HEALTH CARE LOGISTICS

GATEWAY PROFESSIONAL PARK

CITY OF GROVE CITY, OHIO
HEALTH CARE LOGISTICS
 1612 GATEWAY CIRCLE
 SITE DEVELOPMENT PLAN

Staff has reviewed your development plan application for Gateway to Growing located on Lots 9 & 10 of Gateway Circle. The control number for this application is #2016050031 and should be referenced on any future correspondence concerning this matter.

A NORTH (FRONT) ELEVATION
 SCALE: 3/8" = 1'-0"

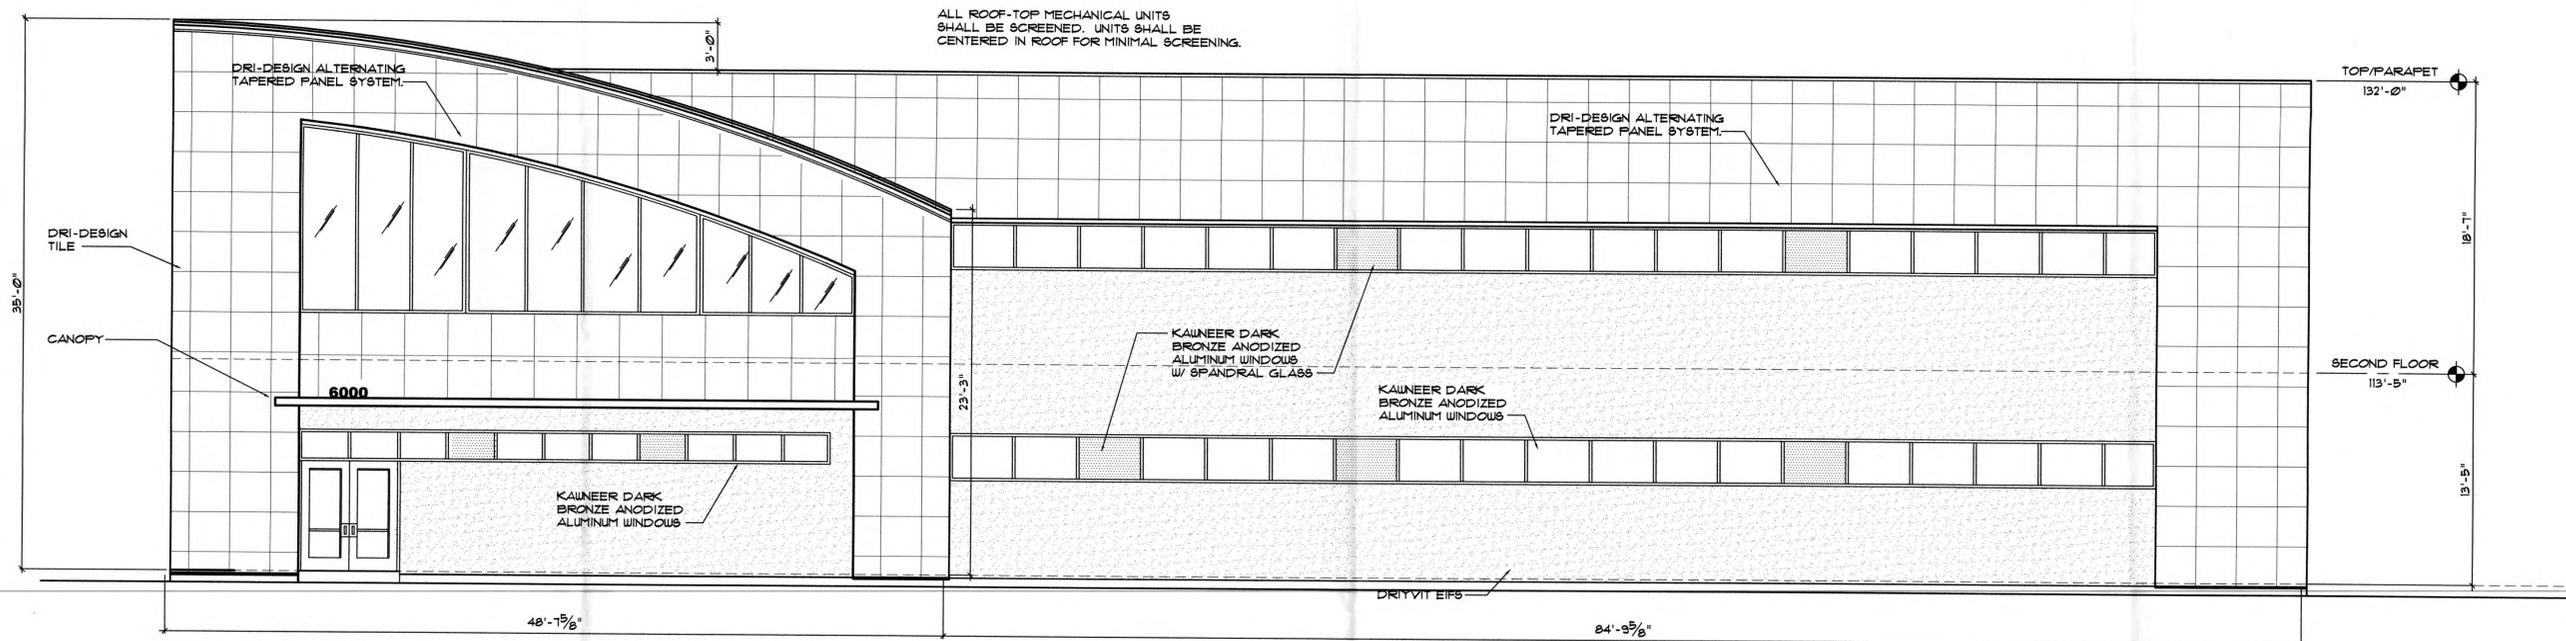
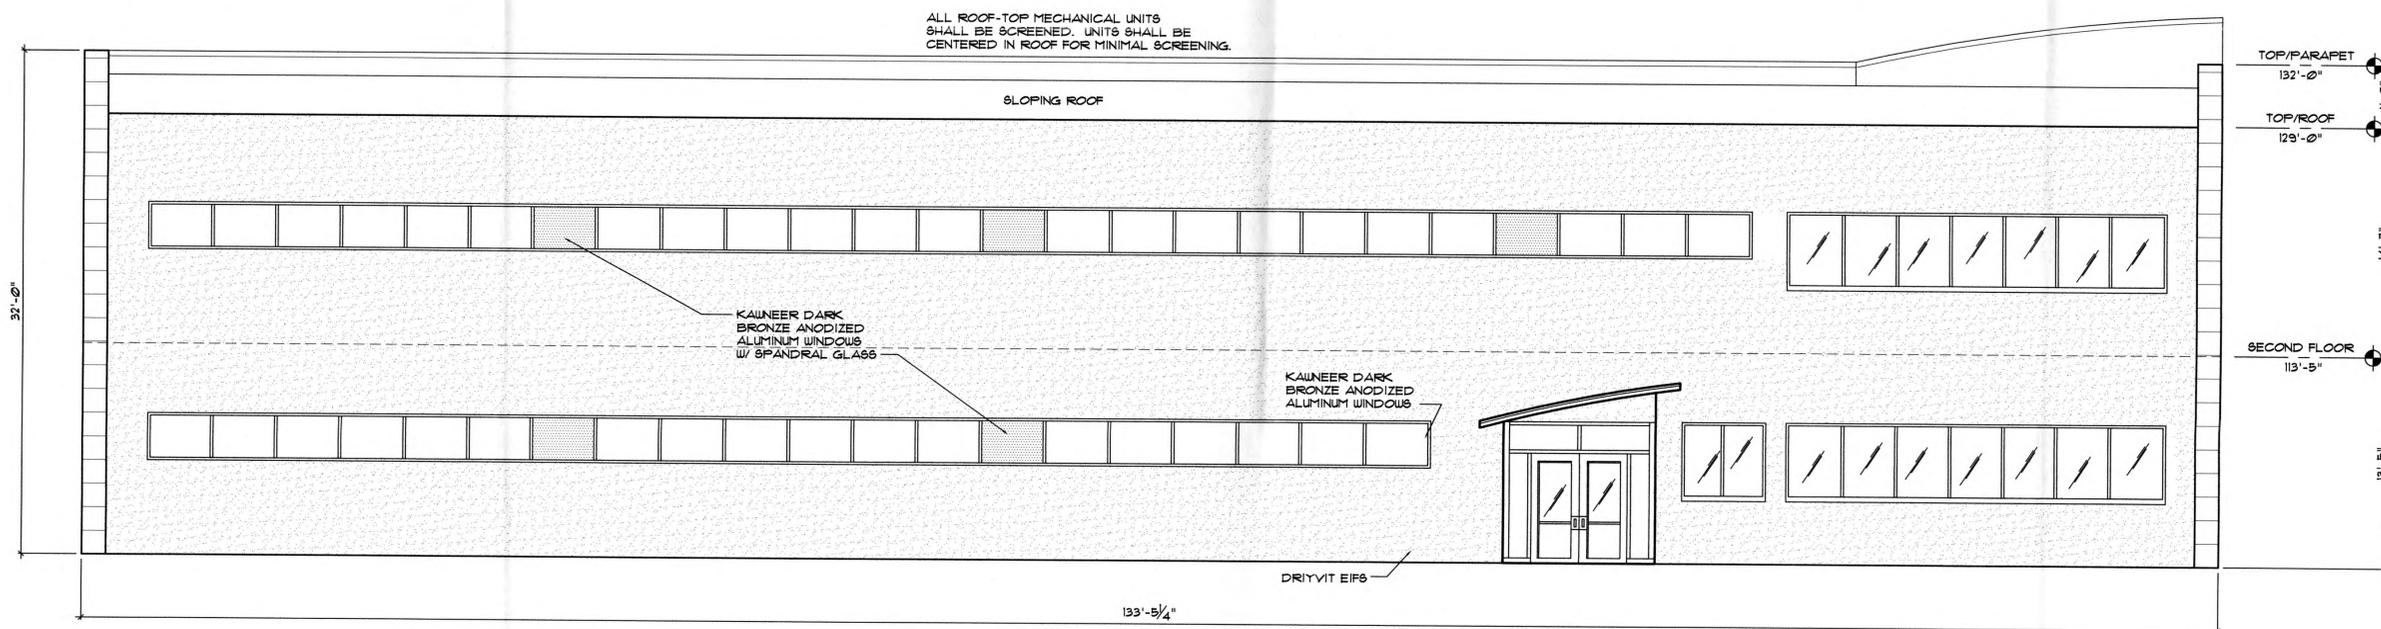
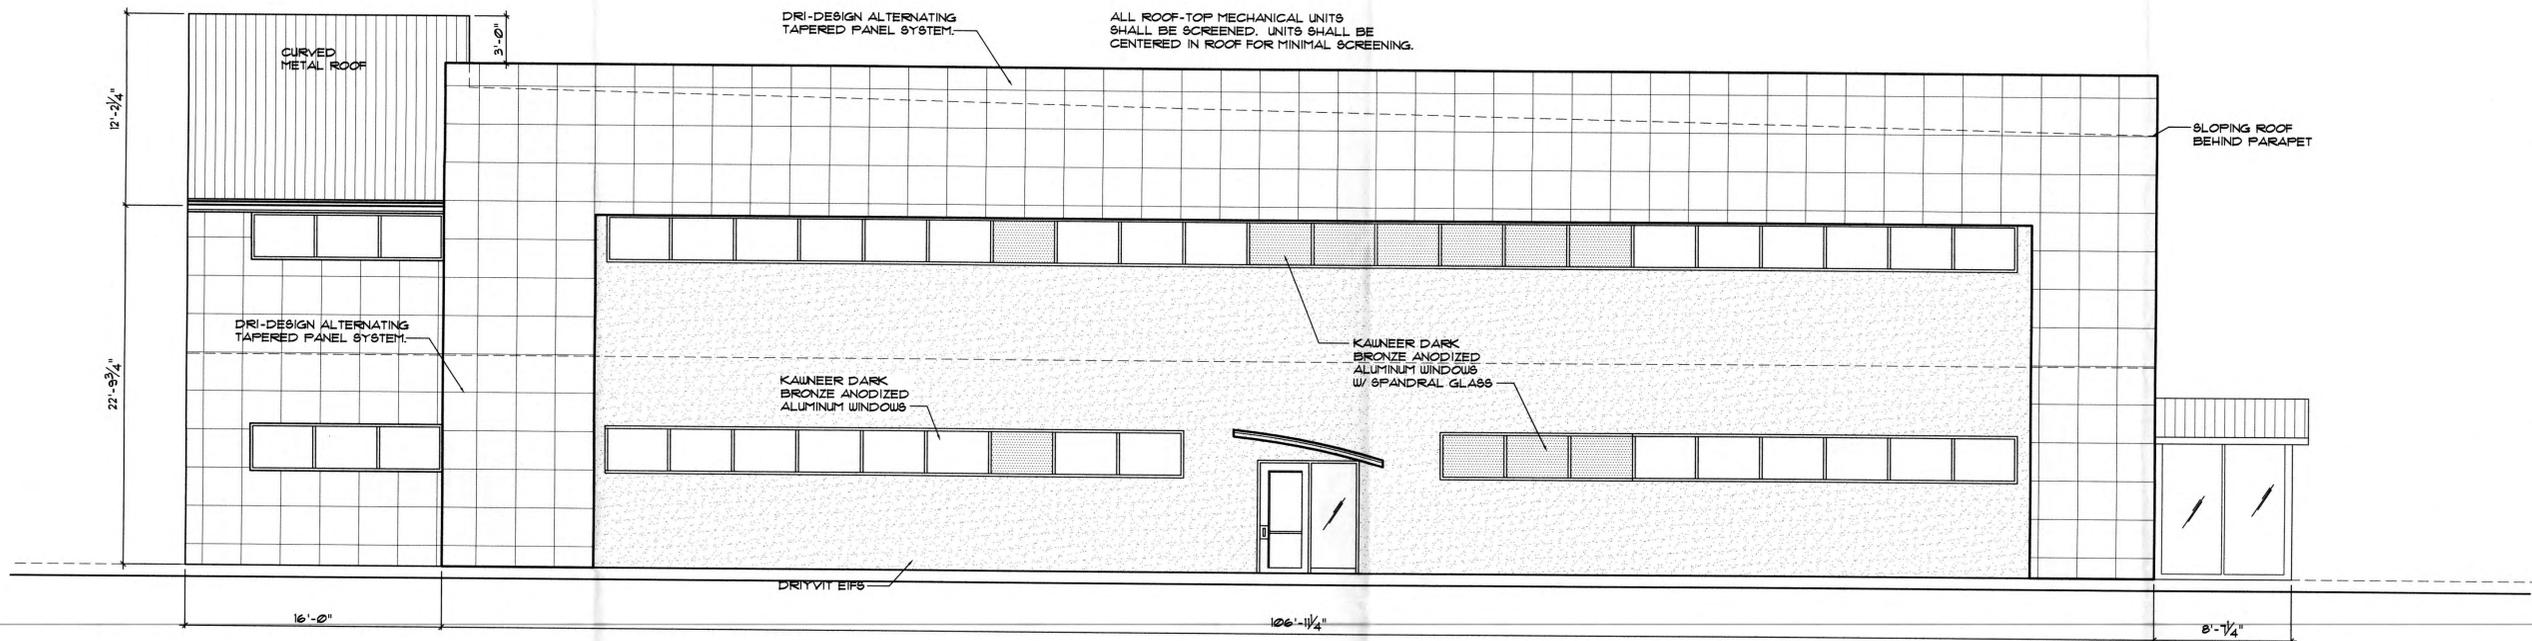
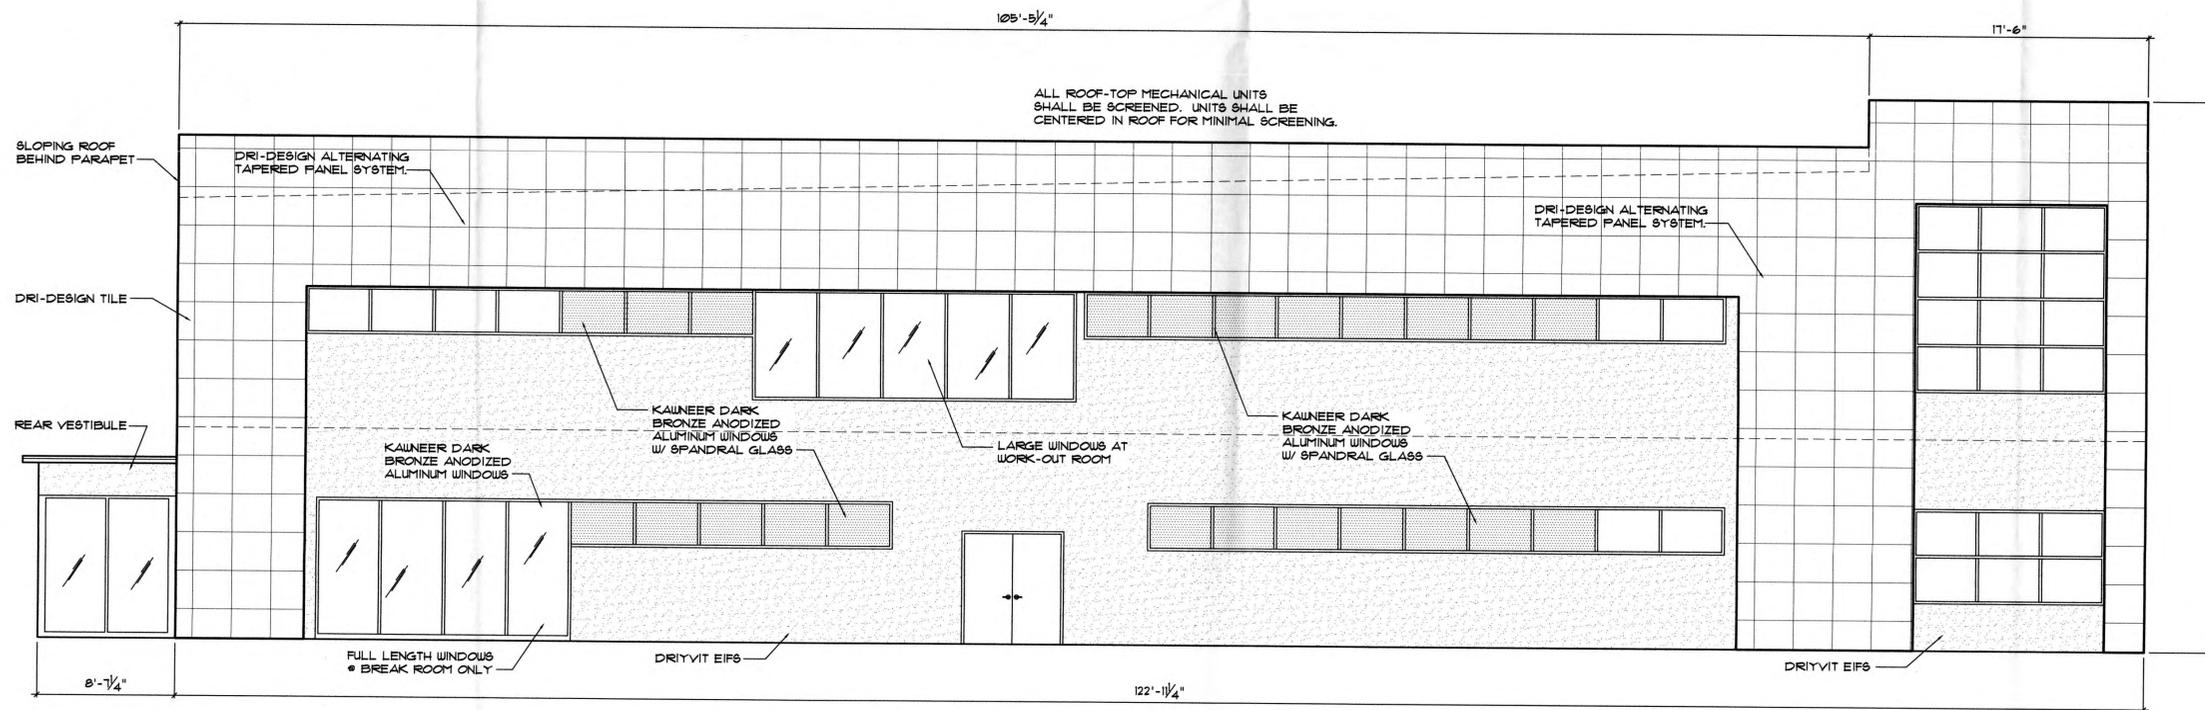
2. A decorative water table or another architectural element should be added to the building with the appearance of stone or block, similar to the Aladdin Shrine Center across Gateway Circle. The same decorative element should be added to the maintenance building.

6. A note should be added to building elevations that all rooftop mechanicals will be screened by the building parapet.
7. The proposed parking space dimensions do not meet the minimum size requirement of 180 square feet and will require a deviation from Planning Commission and City Council; however, staff would be supportive of this deviation.

G DUMPSTER FLOOR PLAN
EL3 SCALE: 1/4" = 1'-0"

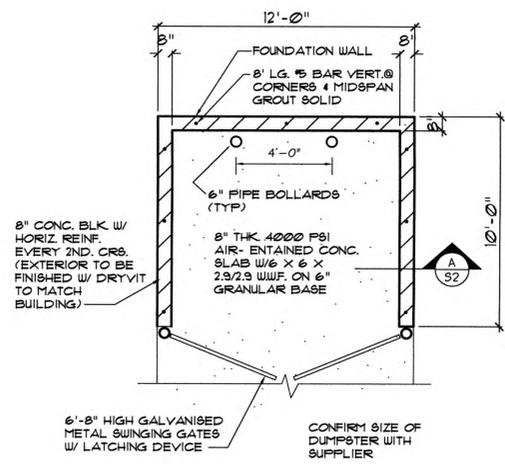
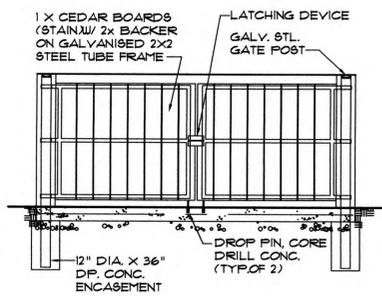
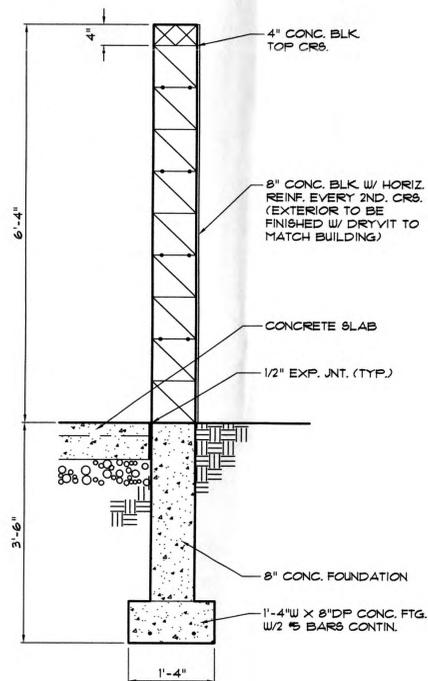
5. The dumpster enclosure should be finished in material matching the primary structure and should incorporate architectural elements noted in comment #2.

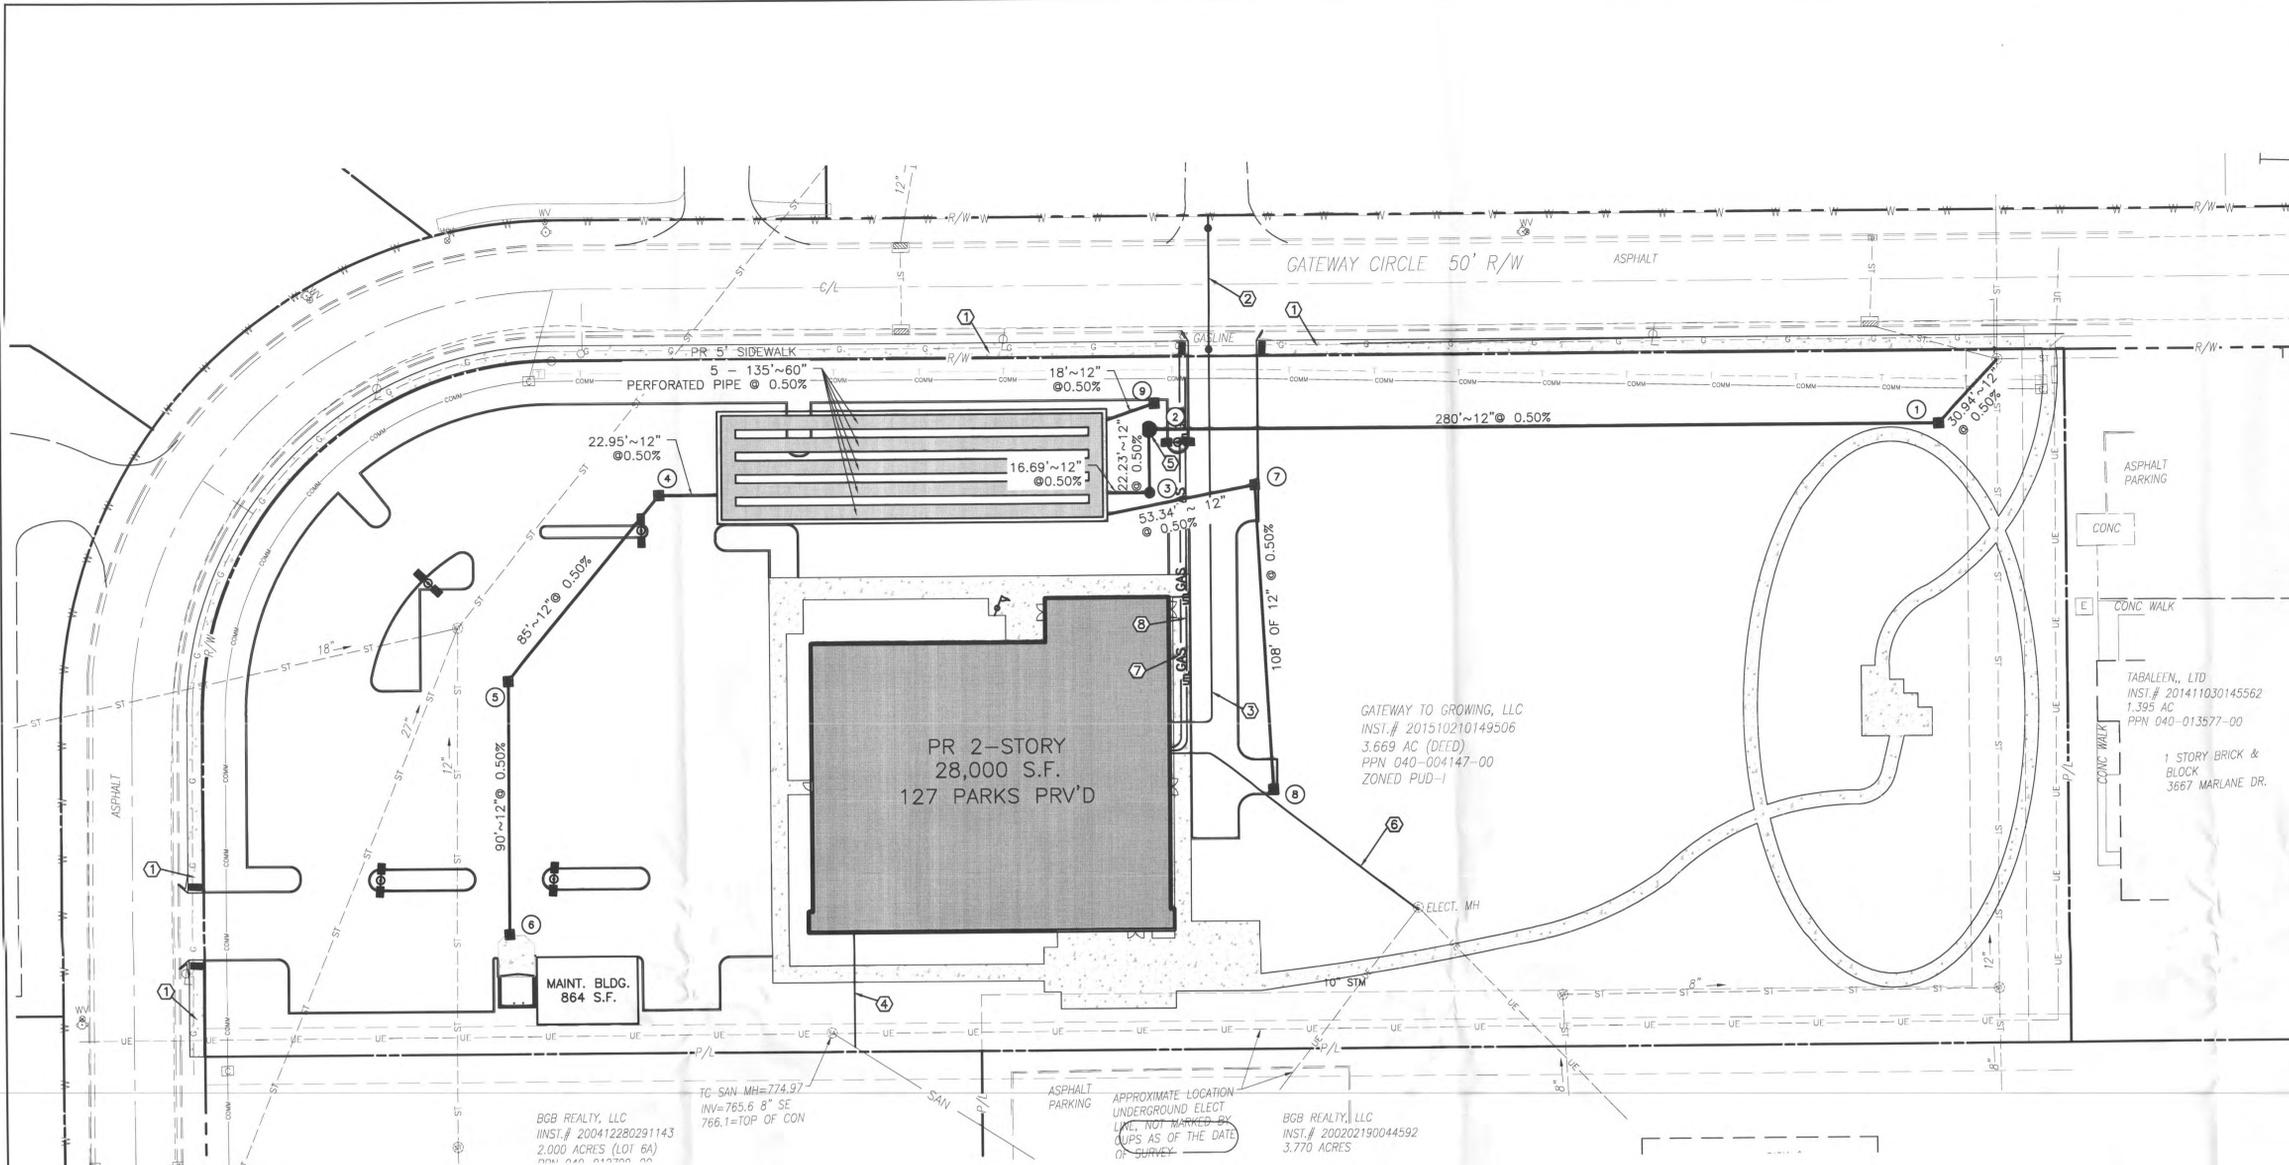
20. The standard drawing referenced in Coded Note 1 on sheet C-3 should be amended to C-GC-46A.
